Product Change Notification

Change Notification #: 113303 - 00
Change Title: Intel® Server System P4308SC2MHGC
PCN 113303-00, Product Design
Update the Air Duct
Date of Publication: October 16, 2014

Figure 1: Post Change Air Duct Overall View

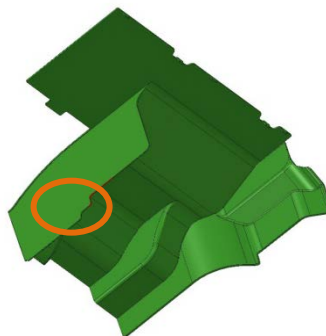
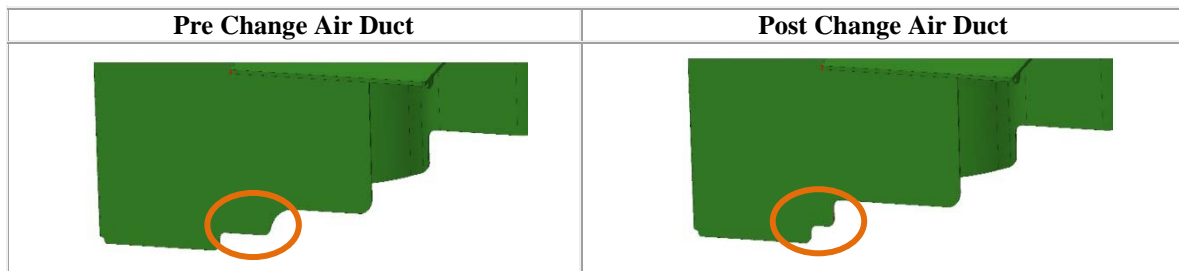
Update the outer edge of the air duct to make its installation easier.
